Serial: RNP-RA/04-0014

H. B. ROBINSON STEAM ELECTRIC PLANT, UNIT NO. 2  
DOCKET NO. 50-261/LICENSE NO. DPR-23

SUPPLEMENT TO AMENDMENT REQUEST REGARDING FULL  
IMPLEMENTATION OF THE ALTERNATIVE SOURCE TERM (TAC NO. MB5105)

### **RESPONSES TO NRC QUESTIONS**

**HBRSEP, Unit No. 2 - LOCA Containment HVAC Flow Modeling**

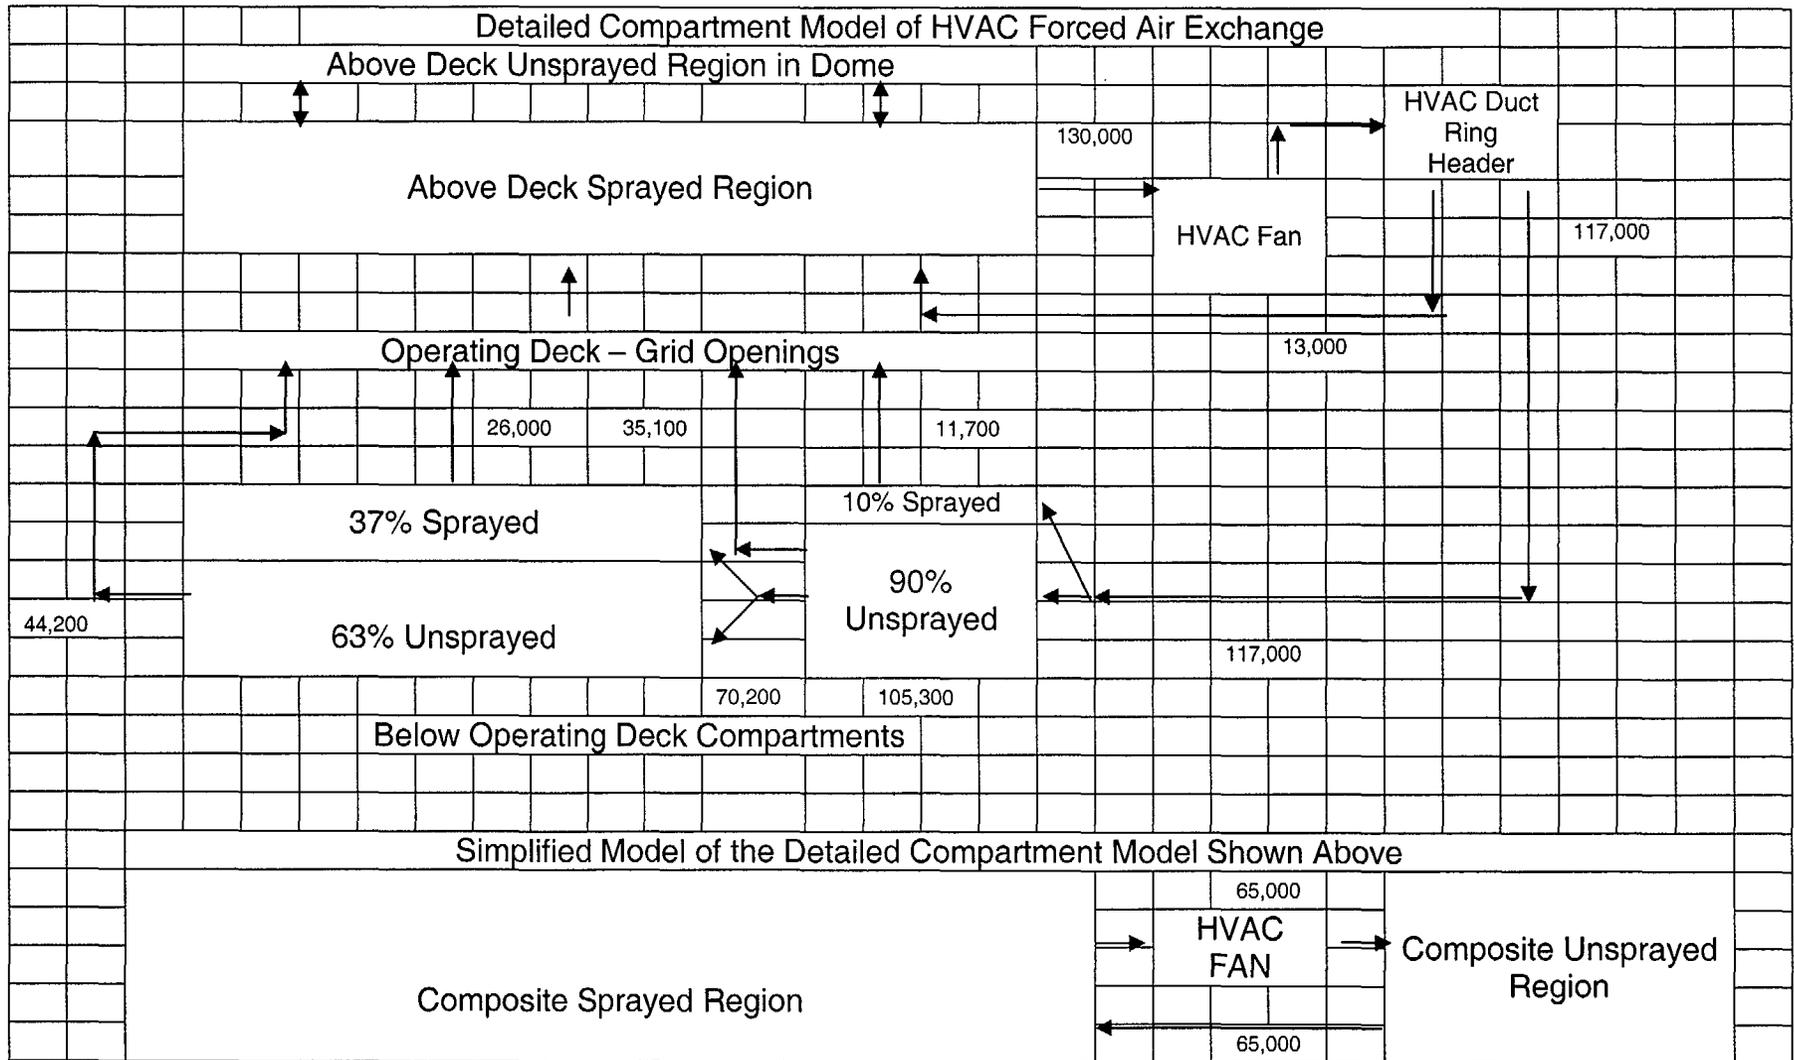
### **NRC Question 8**

In the LOCA dose analysis, the licensee has used a transfer rate of 130,000 cfm from the sprayed region of the containment to the unsprayed region of the containment, and likewise a 130,000 cfm flow from the unsprayed region to the sprayed region. This transfer rate is based on forced recirculation flow from two 65,000 cfm containment cooling fans. Provide additional justification for the use of the 130,000 cfm transfer rate between the two containment zones.

#### 5. Mixing Rate Between the Sprayed and Unsprayed Region

In the original calculation, it was assumed that the forced ventilation flow of 130,000 cfm provided by two recirculation fans provided a flow of 130,000 cfm from the sprayed region to the unsprayed region, and also from the unsprayed region to the sprayed region. To resolve NRC staff questions on this approach, a detailed analysis of the ventilation flow patterns within the containment was performed. Based on that evaluation, it was determined that the initially assumed mixing rate flows were a non-conservative simplification.

The revised evaluation uses a mixing rate flow of 65,000 cfm from the sprayed to the unsprayed region, and 65,000 cfm from the unsprayed region to the sprayed region. The

*$(105,300 + 2 \times 44,200) \div 3$ , or about 65,000 cfm (to the nearest 1000 cfm). This is 50% of the total 130,000 cfm forced air flow rate.*

To aid the understanding of the above description, a diagram is provided at the end of this attachment to depict the air flow pathways being discussed.
